**Council of the
European Union**

14120/18
ADD 1

From:	European Commission
date of receipt:	9 November 2018
To:	General Secretariat of the Council
No. Cion doc.:	D058981/02 - Annexes
Subject:	ANNEXES to the Commission Regulation (EU) .../... amending Regulation (EU) 2017/2400 and Directive 2007/46/EC of the European Parliament and of the Council as regards the determination of the CO_2 emissions and fuel consumption of heavy-duty vehicles

amending Regulation (EU) 2017/2400 and Directive 2007/46/EC of the European Parliament and of the Council as regards the determination of the CO2 emissions and fuel consumption of heavy-duty vehicles

1.5.1 Example of the certification mark (joined marking)

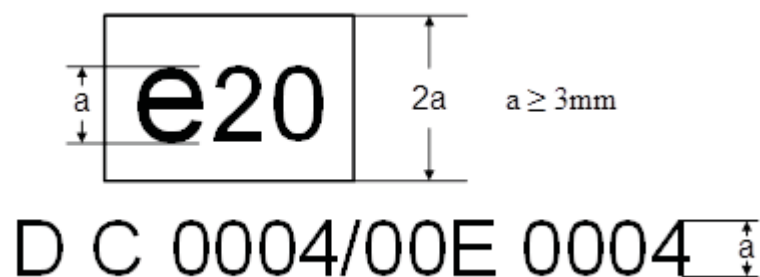
(b) points 1.5 and 1.5.1 are replaced by the following:

"1.5   In the case that the certification in accordance with this Regulation is granted at the same time as the type approval for an engine as separate technical unit in accordance with Regulation (EU) No 582/2011, the marking requirements laid down in point 1.4 may follow, separated by '/', the marking requirements laid down in Appendix 8 to Annex I to Regulation (EU) No 582/2011.

The above certification mark affixed to an engine shows that the type concerned has been certified in Poland (e20), pursuant to Regulation (EU) No 582/2011. The "D" indicates Diesel followed by a "C" for the emission stage followed by four digits (0004) which are those allocated by the approval authority to the engine as the base approval number for Regulation (EU) No 582/2011. After the slash the first two figures are indicating the sequence number assigned to the latest technical amendment to this Regulation, followed by a letter "E" for engine, followed by four digits allocated by the approval authority for the purpose of certification in accordance with this Regulation ('base approval number` to this regulation).";

"1.5 Example of the certification mark

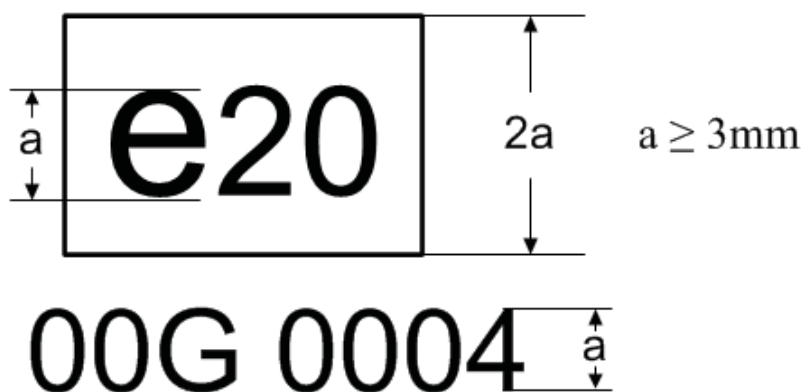
(c) point 1.5 is replaced by the following:

The above certification mark affixed to a transmission, torque converter (TC), other torque transferring component (OTTC) or additional driveline component (ADC) shows that the type concerned has been certified in Poland (e20), pursuant to this Regulation. The first two digits (00) are indicating the sequence number assigned to the latest technical amendment to this Regulation. The following digit indicates that the certification was granted for a transmission (G). The last four digits (0004) are those allocated by the approval authority to the transmission, as the base approval number.";

"*Figure 2*

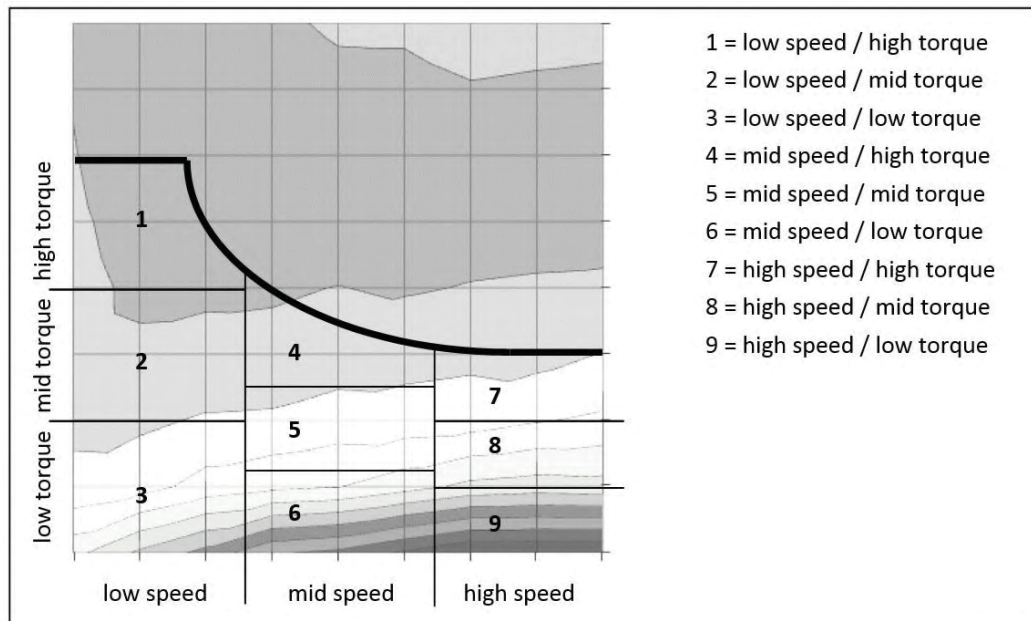
(7)   in point 6.2.1, Figure 2 is replaced by the following:

Speed and torque range for conformity of the certified CO_2 emissions and fuel consumption related properties testing

1 = low speed / high torque	
2 = low speed / mid torque	
3 = low speed / low torque	
4 = mid speed / high torque	
5 = mid speed / mid torque	
6 = mid speed / low torque	
7 = high speed / high torque	
8 = high speed / mid torque	
9 = high speed / low torque
